Littleton & Harestock Parish Council (LHPC) Parish Office, The Hall Way, Littleton, SO22 6QL

Planning Team (SJM), Avison Young, 65 Gresham Street, London, EC2V 7NQ.

15th January 2021

REDEVELOPMENT OF MOD FLOWERDOWN ESTATE (SIR JOHN MOORE BARRACKS) RESPONSE TO THE FIRST PUBLIC CONSULTATION EXERCISE

APPENDIX 2 OVERALL LITTLETON LANDSCAPE AND SETTLEMENT PATTERN

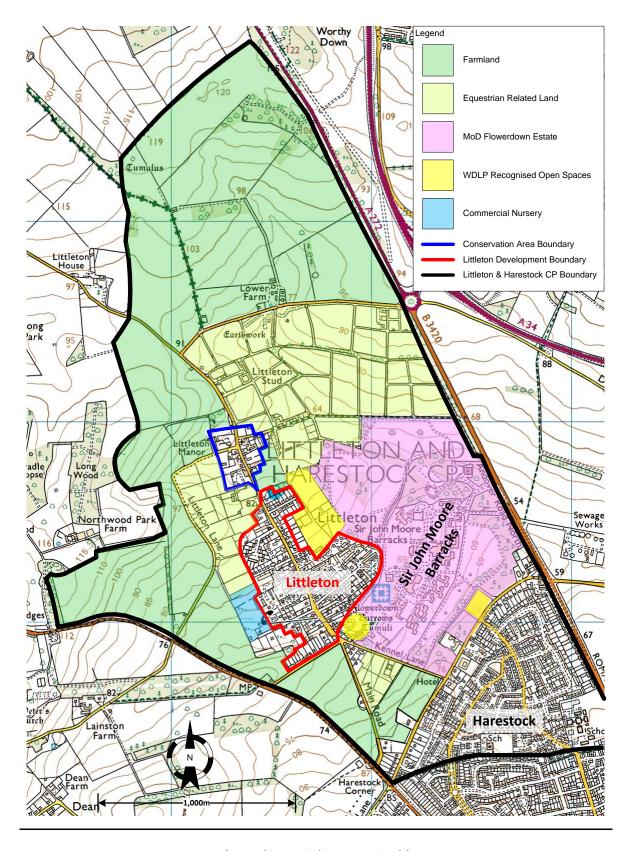
- 3. **Civil Parish Arrangements**. The Planning Team applies the term 'separate community' to the proposed Flowerdown development. The Flowerdown site is positioned within the Littleton and Harestock Civil Parish Boundary, as illustrated in Appendix 2. There are no proposals to change the current Civil Parish boundary, although LHPC may need to modify its name. LHPC assumes:
